YALE FEASIBILITY STUDY AT SADDLE DAM PARK

SUMMARY REPORT

LEWIS RIVER HYDROELECTRIC
PROJECT, WASHINGTON

JULY 2015

SADDLE DAM PARK
 CONCEPTUAL SITE PLAN - ALTERNATE 1
 JANUARY 2015

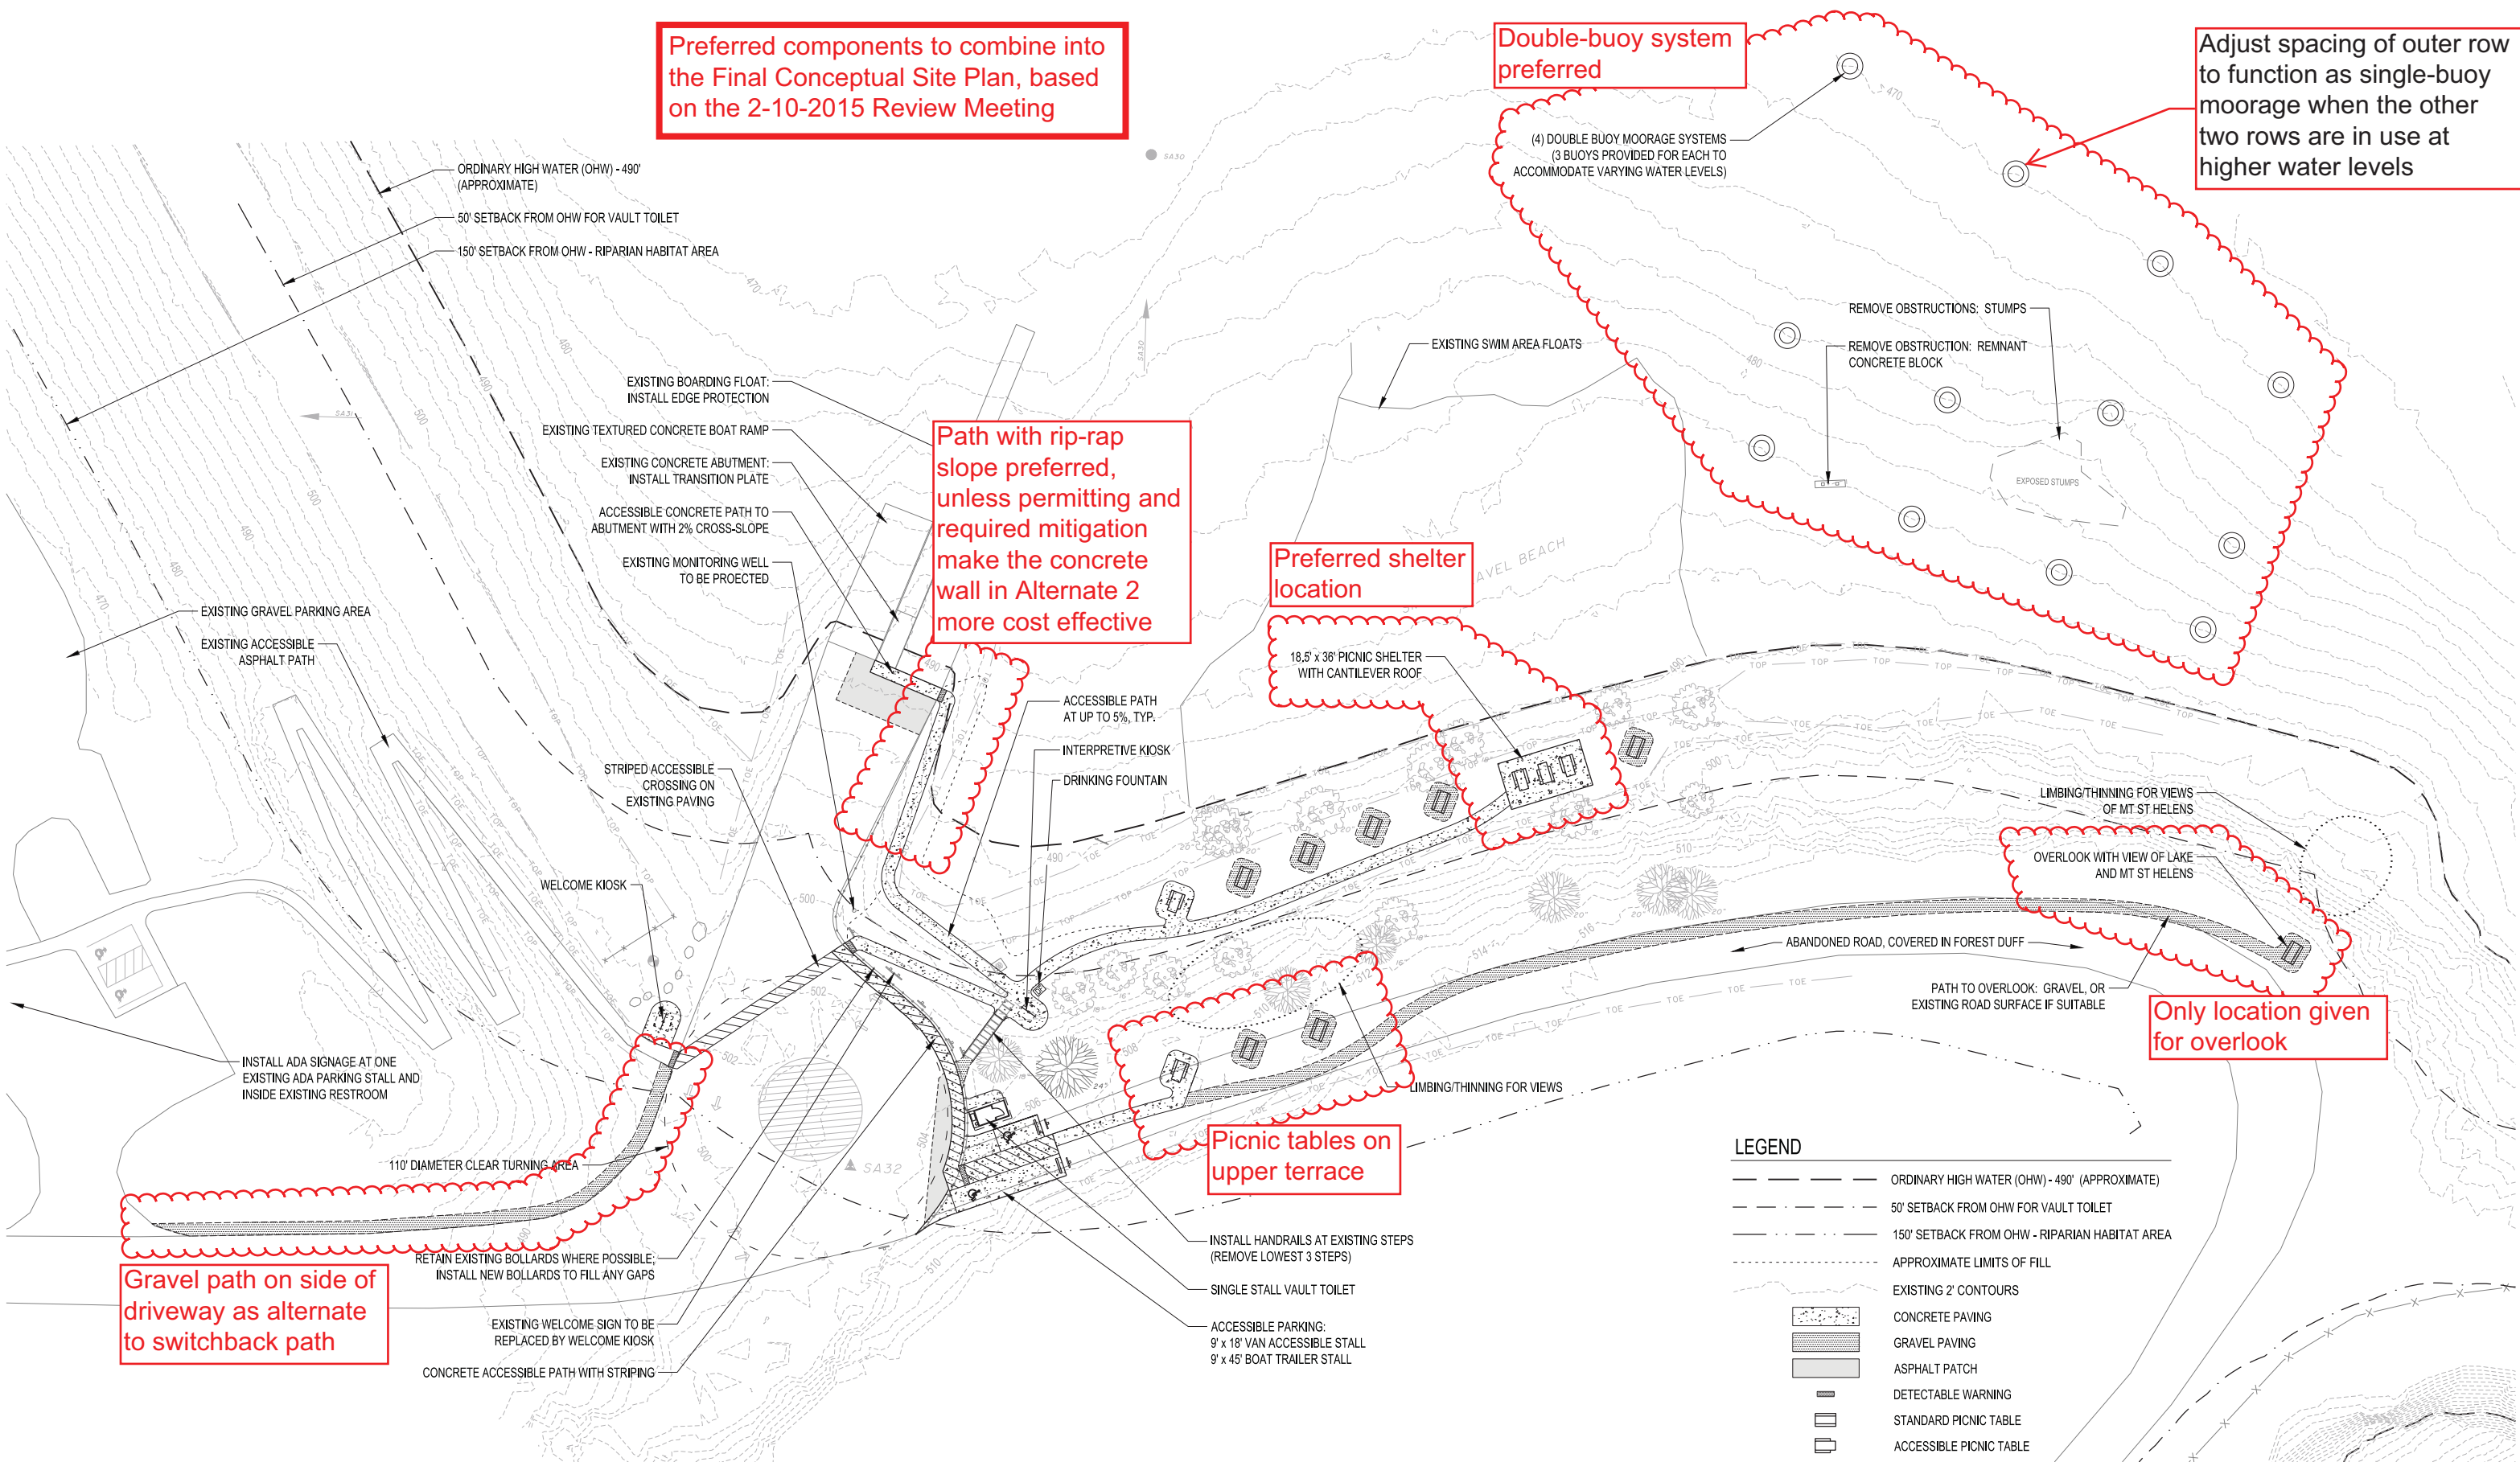
Preferred components to combine into the Final Conceptual Site Plan, based on the 2-10-2015 Review Meeting

Double-buoy system preferred

Adjust spacing of outer row to function as single-buoy moorage when the other two rows are in use at higher water levels

Path with rip-rap slope preferred, unless permitting and required mitigation make the concrete wall in Alternate 2 more cost effective

Preferred shelter location

SADDLE DAM PARK
 CONCEPTUAL SITE PLAN - ALTERNATE 2
 JANUARY 2015

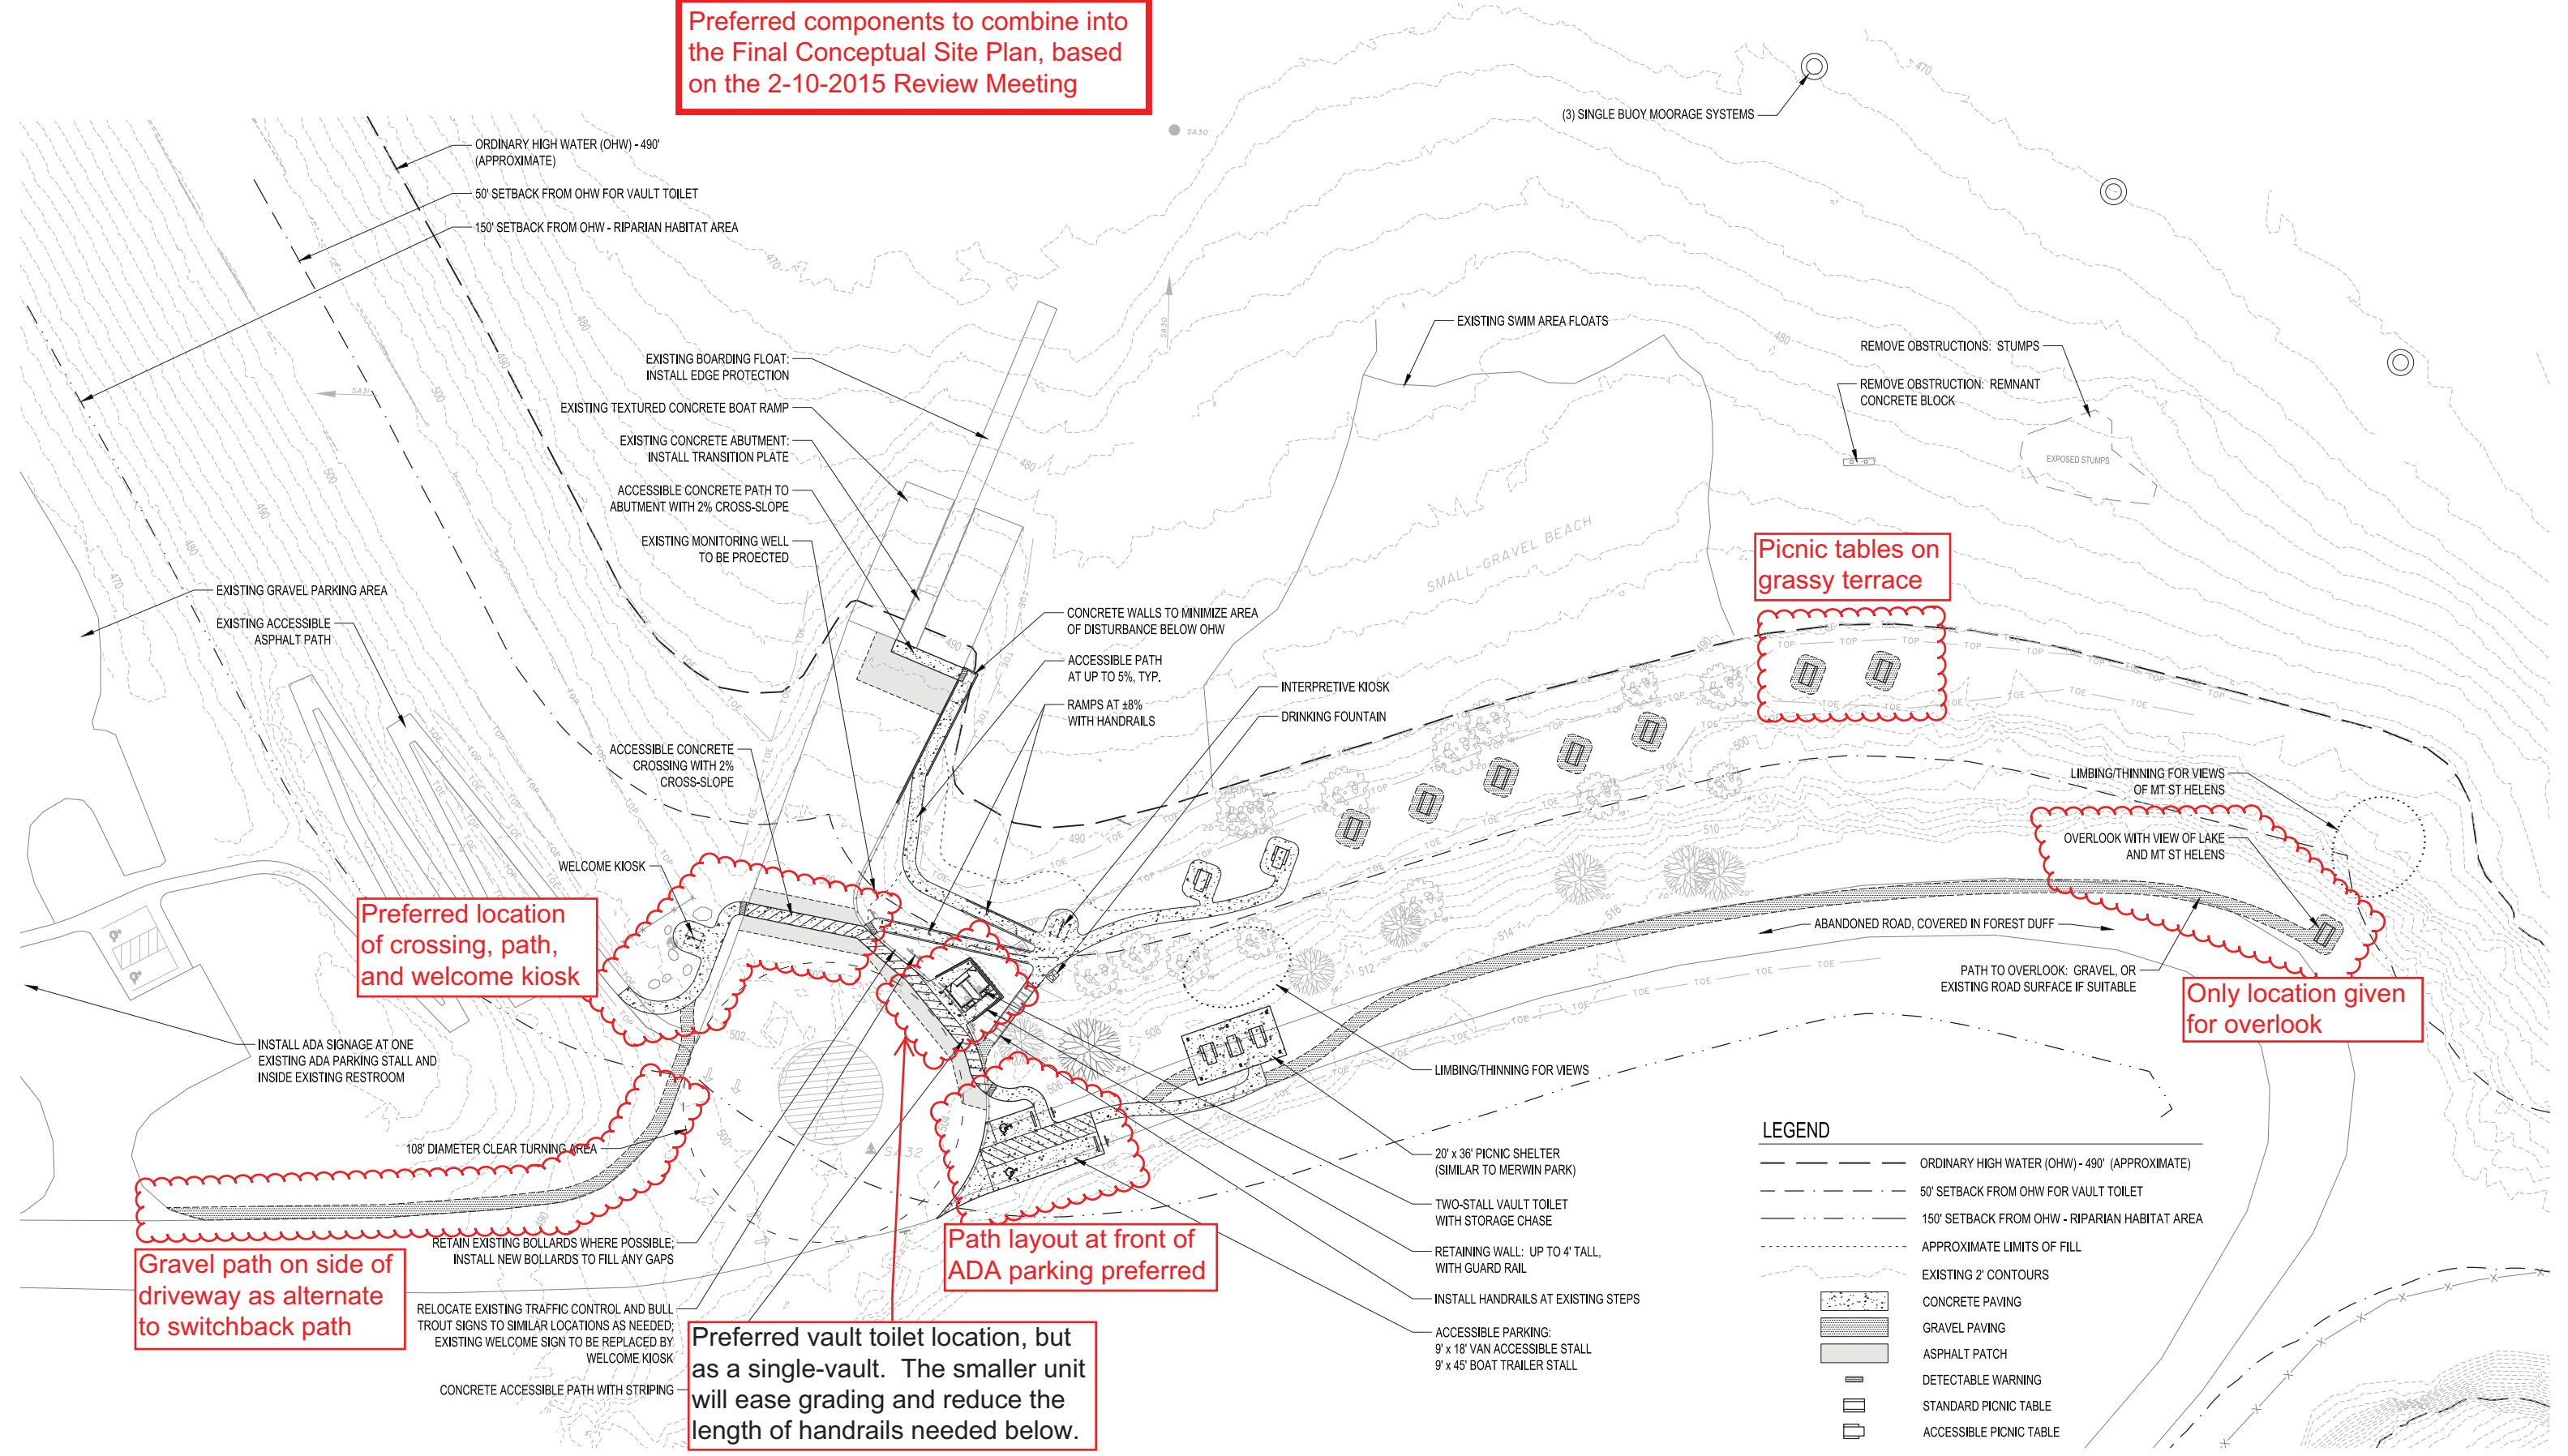
Preferred components to combine into the Final Conceptual Site Plan, based on the 2-10-2015 Review Meeting

Preferred location of crossing, path, and welcome kiosk
